From: Rankin, Jennivine
Sent: Friday, August 01, 2014 9:19 AM
To: ERICKSON, JEFFREY S (JERICKS@entergy.com); Hardy, Jeffery A (jhardy@entergy.com)
Subject: Request for Additional Information: Palisades Aging Management Program for Reactor Vessel Internals (ME9569)
Attachments: RAI.docx

REQUEST FOR ADDITIONAL INFORMATION REGARDING
AGING MANAGEMENT PROGRAM FOR
REACTOR VESSEL INTERNALS AT
PALISADES NUCLEAR PLANT
ENTERGY NUCLEAR OPERATIONS, INC.
DOCKET NO. 50-255

Figure A – Excerpt from Figure 14 of Reference 1

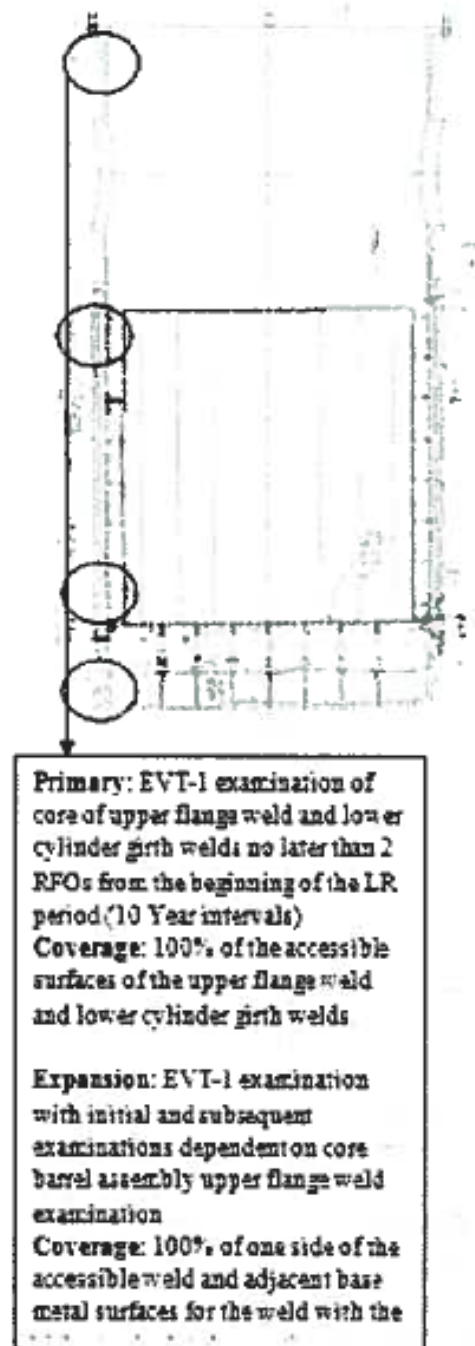
The upper left corner of Figure 14 (Reference 1), shows an elevation cross section of the PNP core support barrel and has four circled areas corresponding to portions to be inspected (Figure A below). The caption states the following:

Primary: EVT-1 examination of core of upper flange weld and lower cylinder girth welds no later than 2 RFOs [refueling outages] from the beginning of the LR [license renewal] period (ten year intervals)

Coverage: 100% of accessible surfaces of upper flange weld and lower cylinder girth welds

Figure B – PNP Lower Core Support Structure – Oval shows presumed location of weld

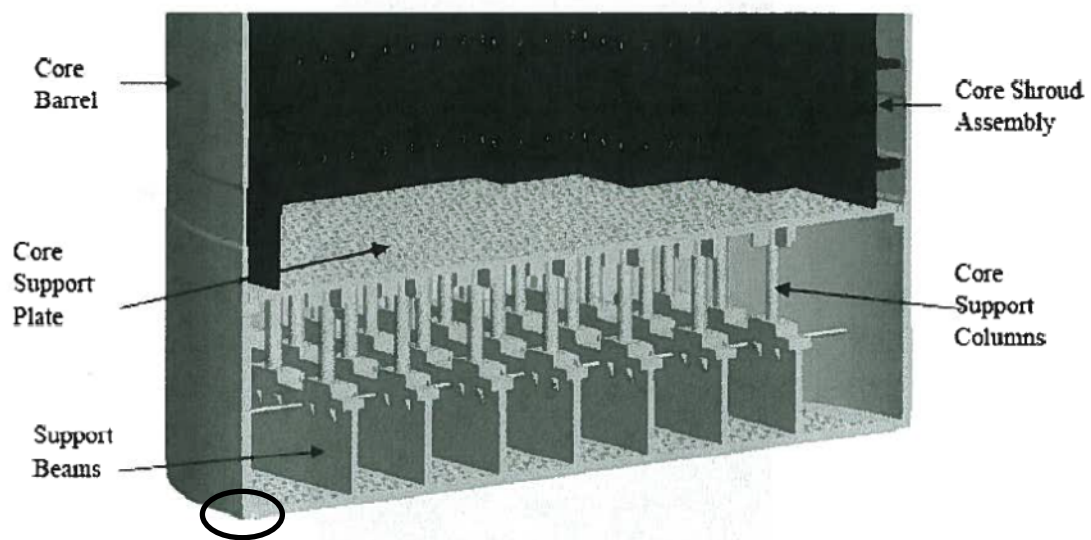
Figure 8 of Reference 1 shows a typical CE core support barrel, while Figure 9 and 10 of Reference 1 show the PNP-specific design. The PNP-specific design appears to have no core support barrel lower flange, but it appears to have a weld (Figure B below) joining the very bottom of the core support bottom to the plate that forms the bottom of the lower core support structure (the corresponding MRP-191 component designation appears to be the "Lower Support Structure – Bottom Plate, Reference 2).

1. Please confirm that the weld joining the very bottom of the core support barrel to the plate that forms the bottom of the lower core support structure (Figure B), is considered a "Core Support Barrel Lower Girth Weld," at PNP and is subject to EVT-1 visual examination as a "Primary" inspection category component.
2. Please confirm that Entergy Nuclear Operations, Inc. understands there to be an error in MRP-227-A, Tables 4-2 and 4-5 in that both the "Core Support Barrel Lower Flange Weld," and "Core Support Barrel Lower Core Barrel Flange," should have been identified as not applicable to PNP.
